UNITED STATES PATENT AND TRADEMARK OFFICE

APPLICATION NO.	FILING DATE	FIRST NAMED INVENTOR	ATTORNEY DOCKET NO.	CONFIRMATION NO.
10/025,904	12/26/2001	Yong Ik Bang	8733.525.00	7612
30827	7590	01/16/2004		
MCKENNA LONG & ALDRIDGE LLP 1900 K STREET, NW WASHINGTON, DC 20006				
			EXAMINER RUDE, TIMOTHY L	
			ART UNIT 2871	PAPER NUMBER

Office Action Summary	Application No.	Applicant(s)	
	10/025,904	BANG ET AL.	
	Examiner	Art Unit	
	Timothy L Rude	2871

DETAILED ACTION

FIG. 1

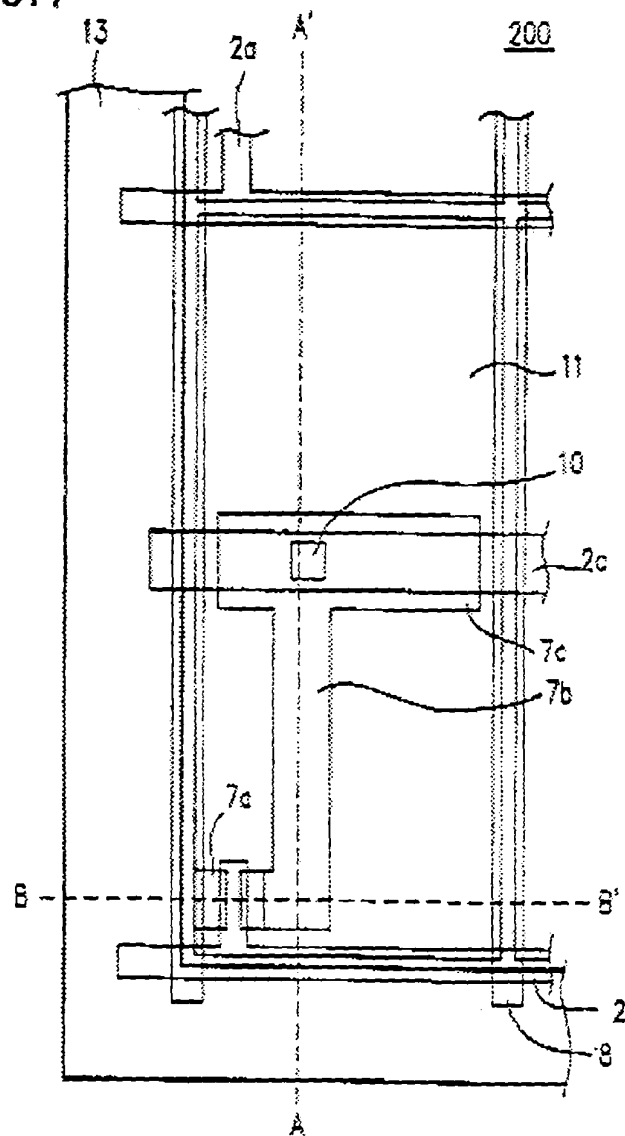
2. Claim 1 is rejected under 35 U.S.C. 102(b) as being anticipated by Shimada et al (Shimada) USPAT 5,877,830.

As to claim 1, Shimada discloses (Title, Abstract, entire patent) a liquid crystal display (LCD) panel comprising:

a first substrate provided with a plurality of gate, 2, and data, 8, lines, the gate lines being arranged to cross the data lines to define a plurality of pixel regions in a matrix

arrangement; a second substrate provided with a black matrix layer (col. 5, lines 50-60) to shield portions other than the pixel regions from light; and liquid crystal layer injected between the first and second substrates, wherein the pixel regions in a peripheral portion of the matrix arrangement has an aperture ratio lower than that of the pixel regions in other portions of the matrix arrangement (col. 6, lines 35-45) in the example where the black matrix overlaps the pixel electrodes, 11.

FIG. 5

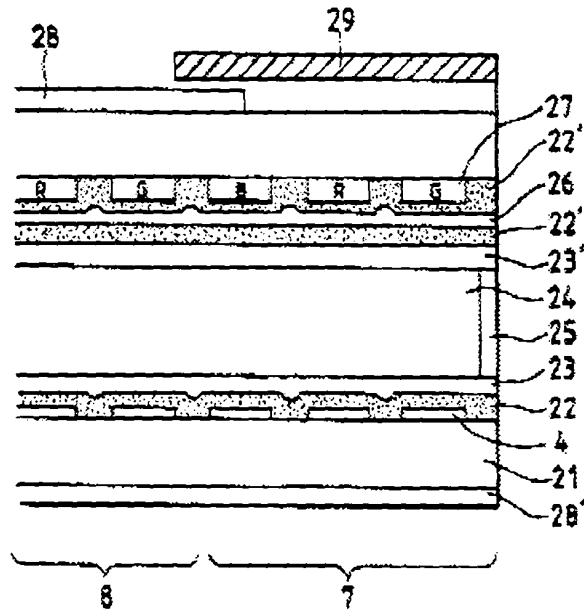
3. Claim 1 is rejected under 35 U.S.C. 102(b) as being anticipated by Sono et al (Sono) USPAT 5,513,028.

As to claim 1, Sono discloses (Title, Abstract, entire patent) a liquid crystal display (LCD) panel comprising:
a first substrate provided with a plurality of gate and data lines, the gate lines being arranged to cross the data lines to define a plurality of pixel regions in a matrix arrangement; a second substrate provided with a shield plate, 29 (Applicant's black matrix layer), to shield portions other than the pixel regions from light; and liquid crystal layer injected between the first and second substrates, wherein the pixel regions in a peripheral portion of the matrix arrangement has an aperture ratio lower than that of the pixel regions in other portions of the matrix arrangement due to shielding.
